Owner Change Order

Project No.: 021192
Project Name: 9 Riverside Police Station
Contract Date: 11/18/2024
Contract Number: 021192
Change Order Number: 00002
Owner's CO Number: 2

Project: 9 Riverside Police Station

1 ELECTRICAL OVERALL UTILITY GRADING DRAINAGE - SITE PLAN
ES100 3/4" = 1'-0"

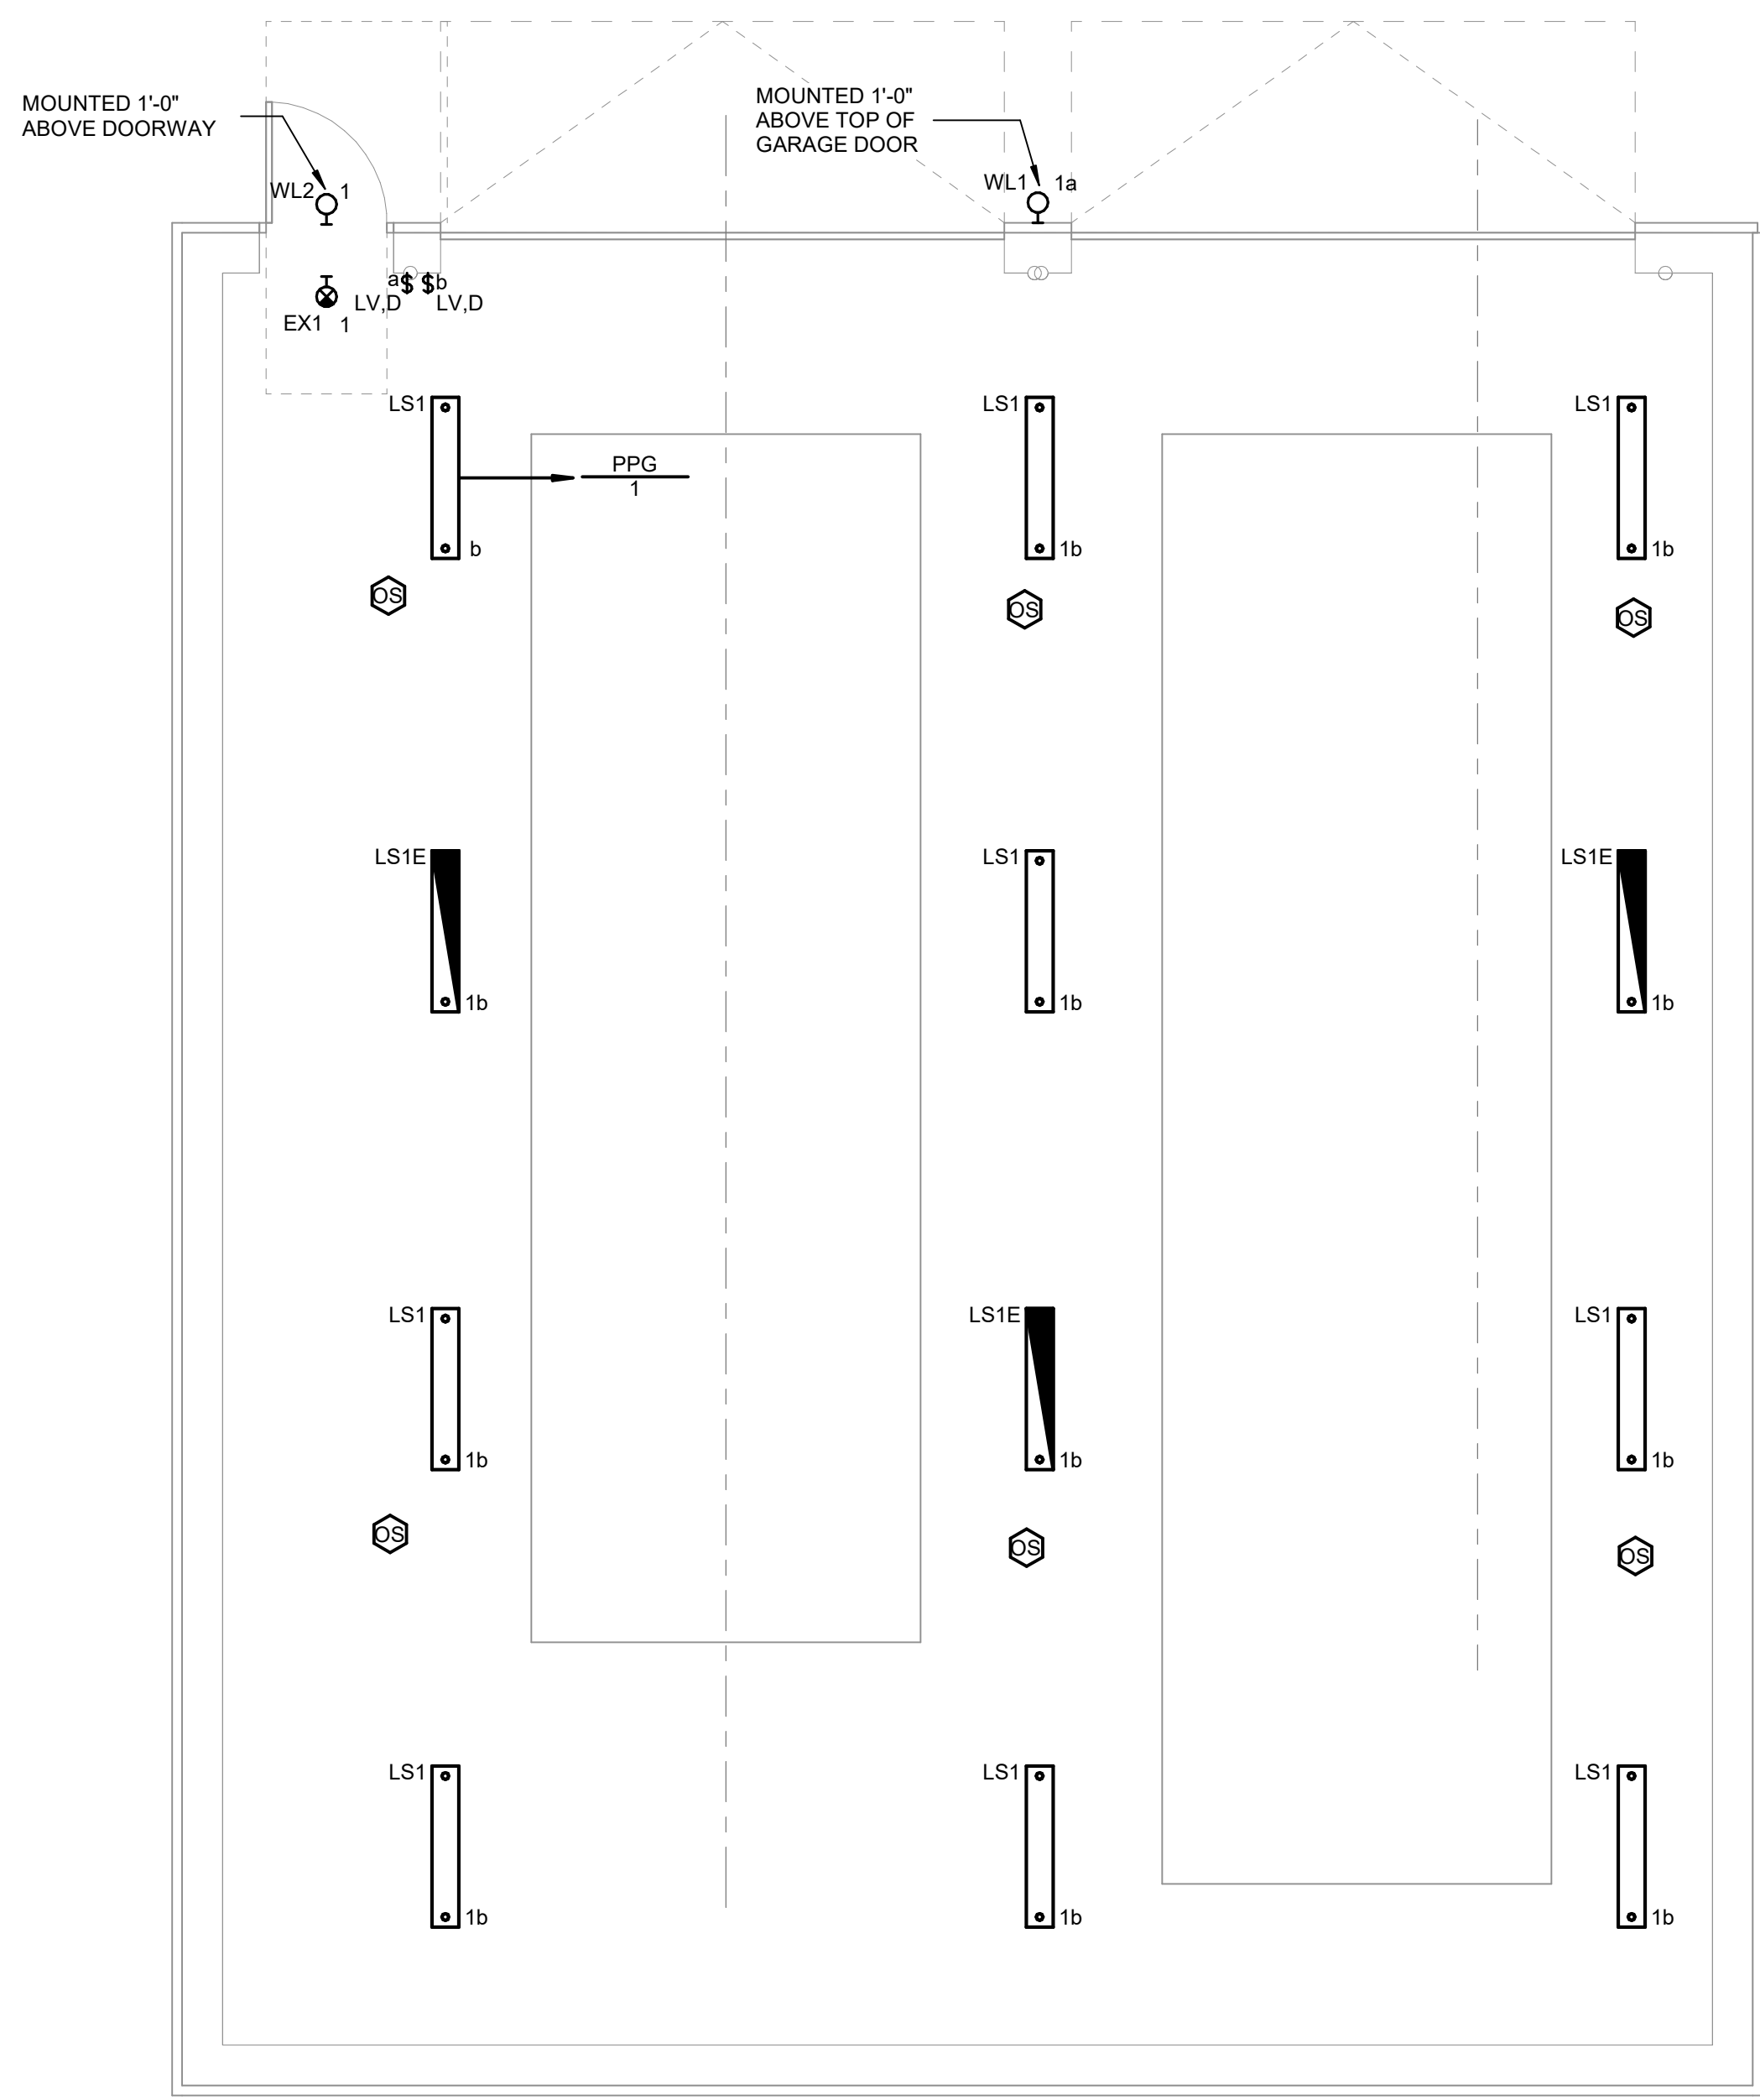
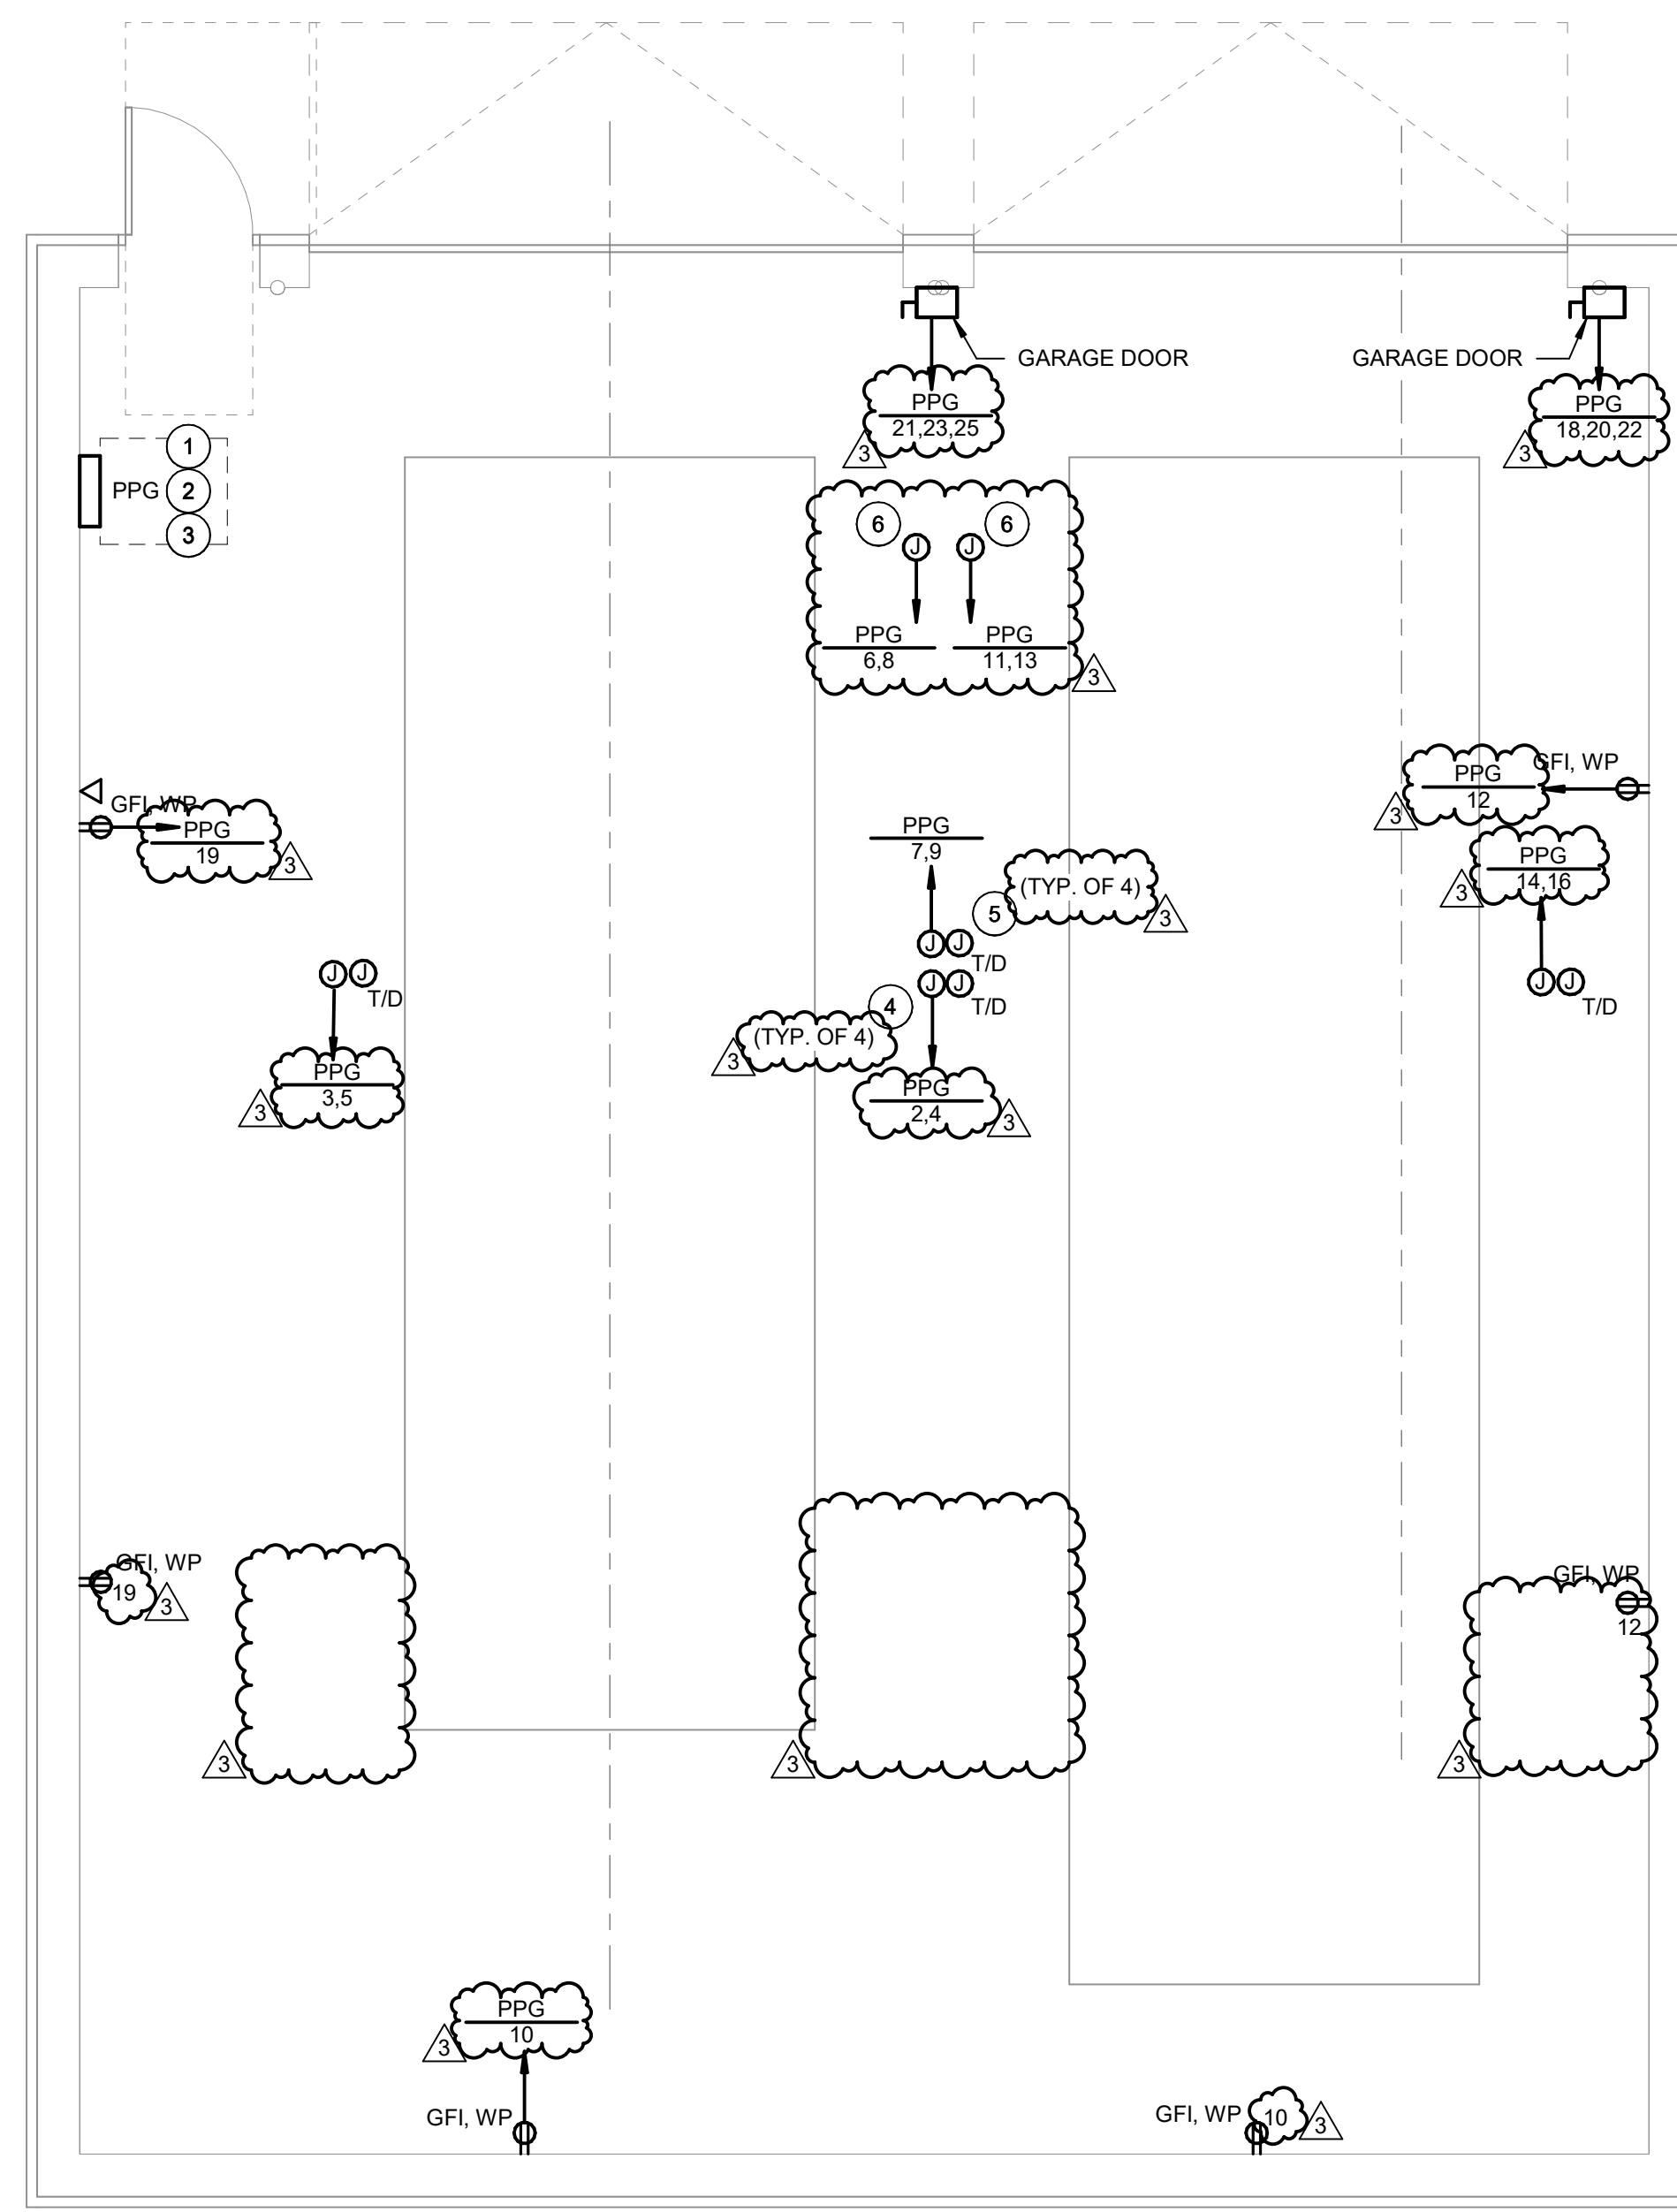
Drawing ES-1 - Site Plan - Conduits from MDP-1 to new Garage Panel PPG will change from 1-1/4" to 1-1/2" Conduits to accomodate (4) #1, (1)#6G. Conduits will change over to PVC exiting the existing building to Garage. Previously installed 1-1/4" emt conduits will be demoed and replaced with 1-1/2" EMT.

2
E310
ELECTRICAL GARAGE LIGHTING PLAN
1/4" = 1'-0"

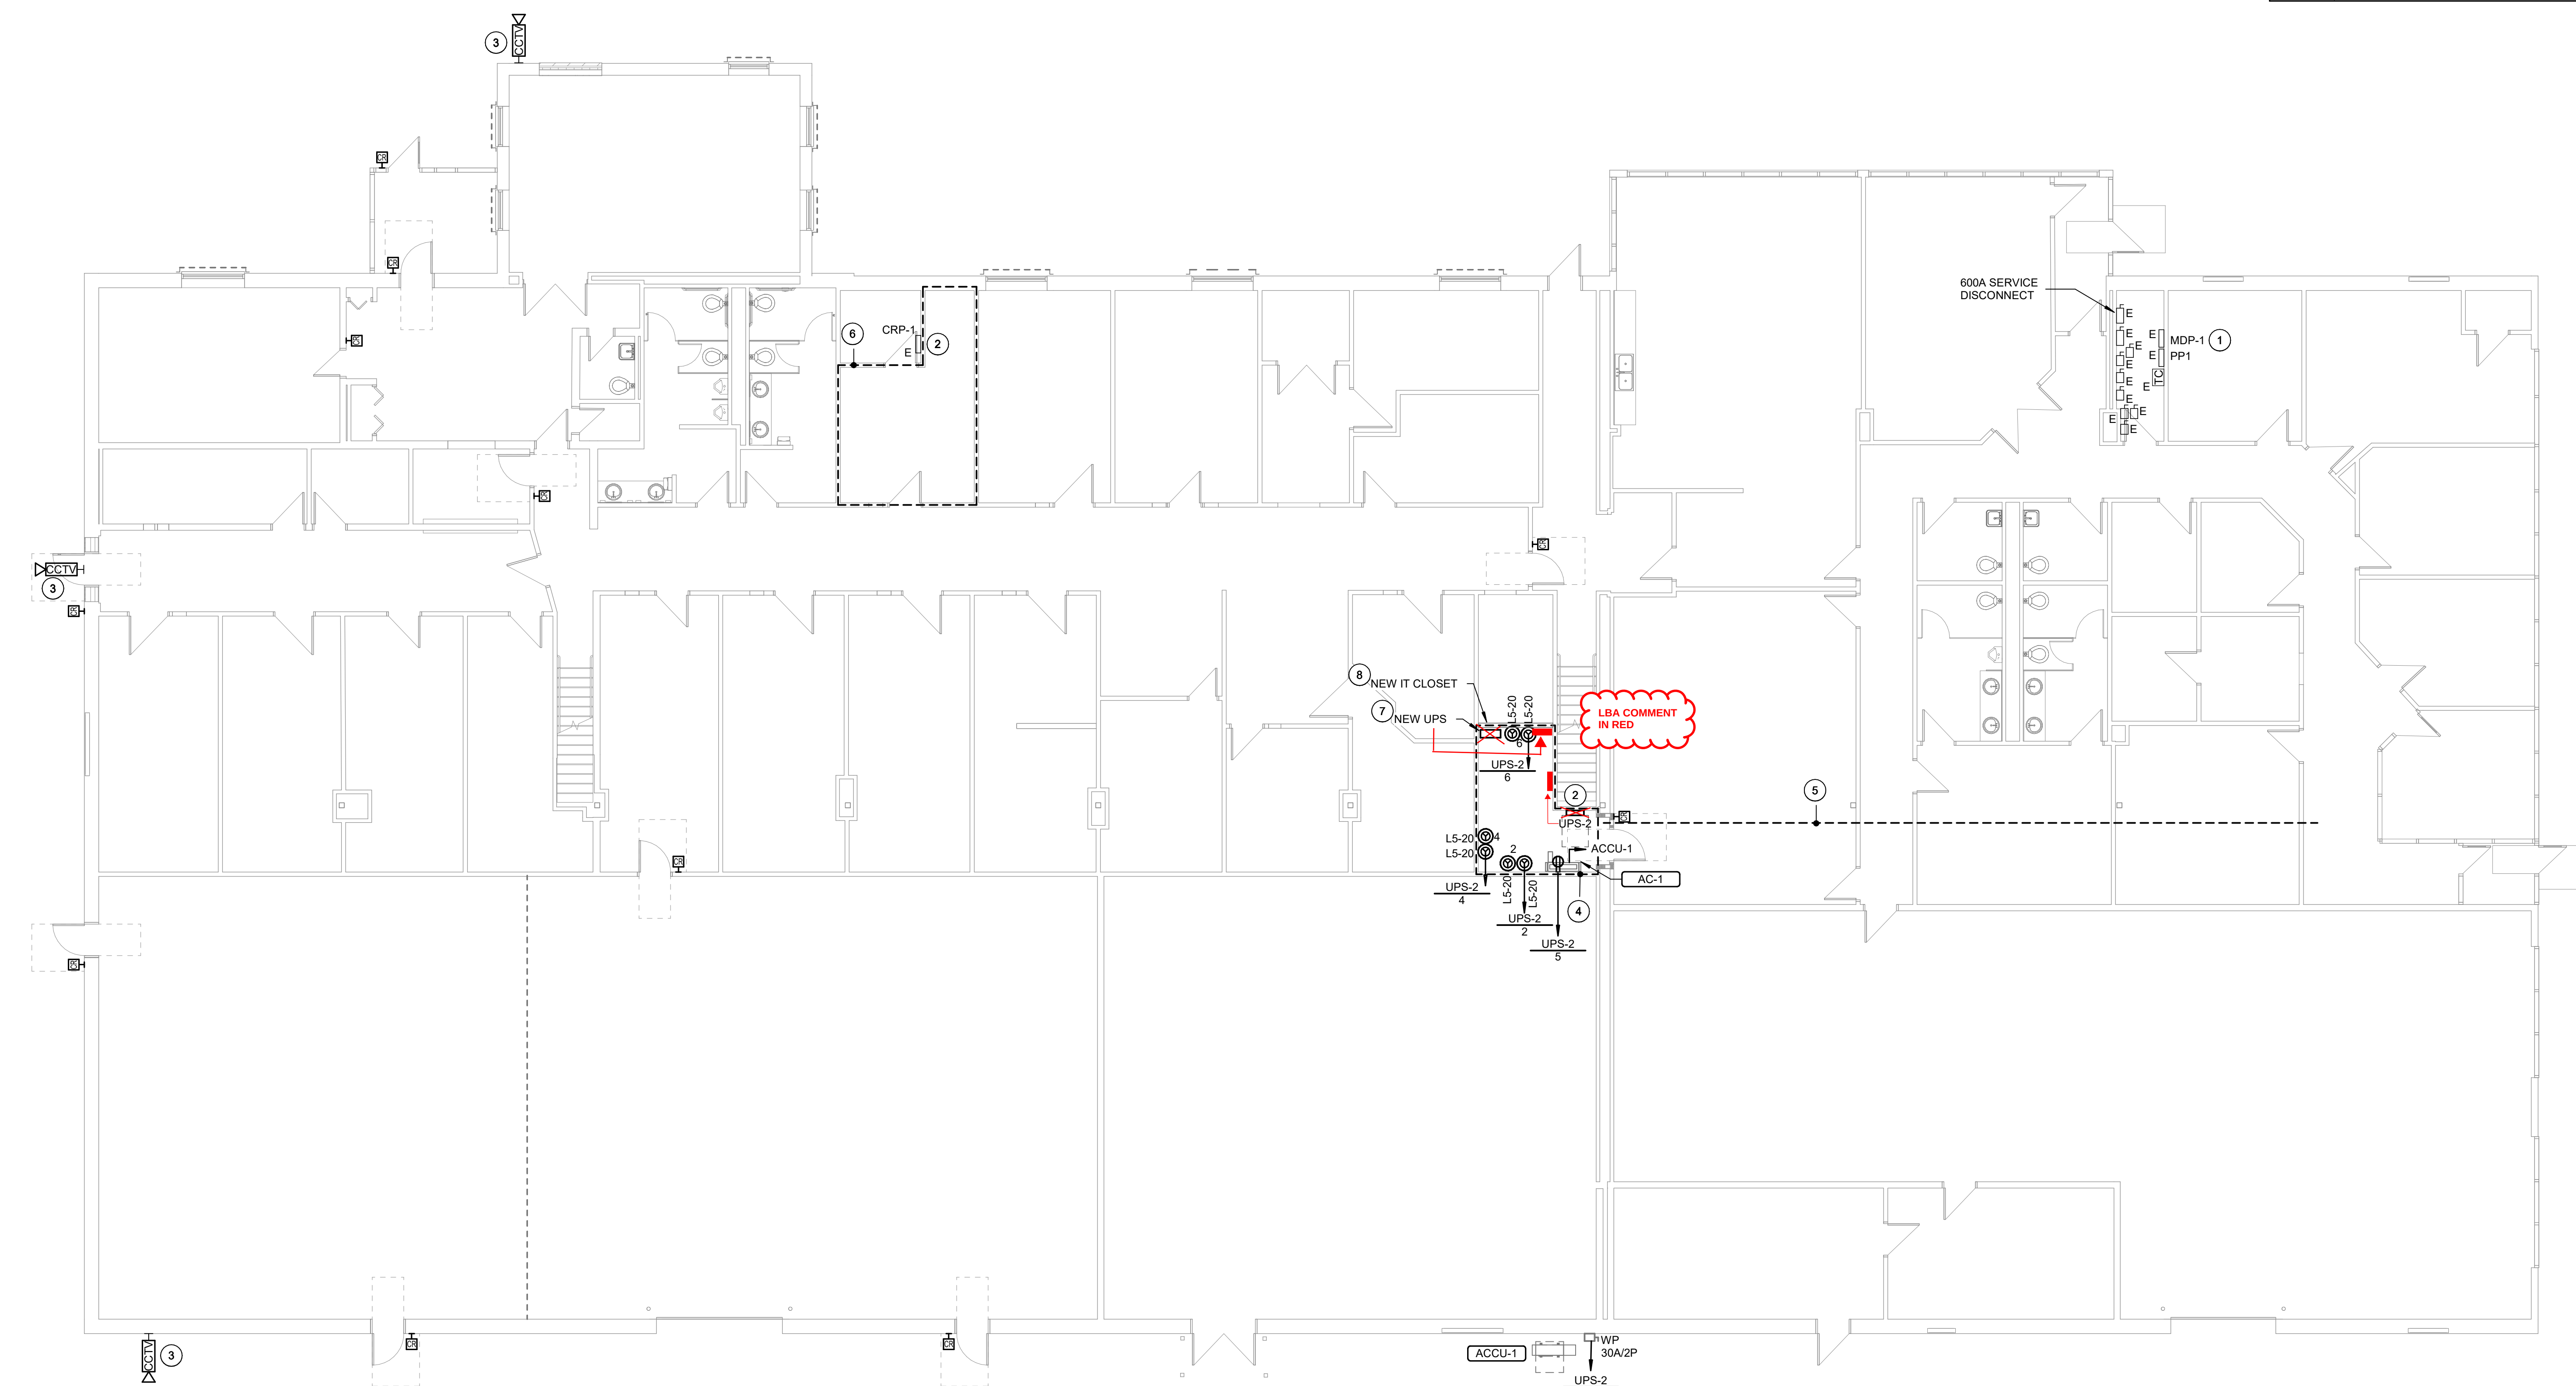
Drawing E310 - Electrical Garage Plan - Electrical plans shows a change of (6) cord resls. A credit for the (2) deleted cord reels will be given. There are now (4) 50A, 208V 1P and (2) 20A, 208V, 1P. Feeds for 50A Cord reels will now change to #6 conductors

- KEYNOTES**
1. RUN #1, 1#6G IN 1-1/2" C FROM MDP-1 LOCATED WITHIN MAIN ELECTRICAL ROOM TO NEW GARAGE PANELBOARD PPG. PROVIDE WITH NEW 100A/3P CIRCUIT BREAKER TO SERVE PPG.

3. PROVIDE WITH TVSS DEVICE TO NEW PANELBOARD AND CONNECT ONTO LEAD-SIDE.
 4. PROVIDE WITH L14-50R RECEPTACLE ON RETRACTABLE WEATHERPROOF CORD REEL DEVICE TO SERVE TRUCK BATTERY. CORD REEL DEVICE TO BE HARDWIRED TO CEILING JUNCTION BOX. EXACT MOUNTING LOCATION TO BE CONFIRMED IN FIELD. ELECTRICAL CONTRACTOR SHALL CARRY AN ALLOWANCE OF \$1500 FOR CORD REEL DEVICE.

6. PROVIDE WITH L6-20R RECEPTACLE ON RETRACTABLE WEATHERPROOF CORD REEL DEVICE TO SERVE TRUCK ENGINE BLOCK HEATER. CORD REEL DEVICE TO BE HARDWIRED TO CEILING JUNCTION BOX. EXACT MOUNTING LOCATION TO BE CONFIRMED IN FIELD. ELECTRICAL CONTRACTOR SHALL CARRY AN ALLOWANCE OF \$1500 FOR CORD REEL DEVICE.
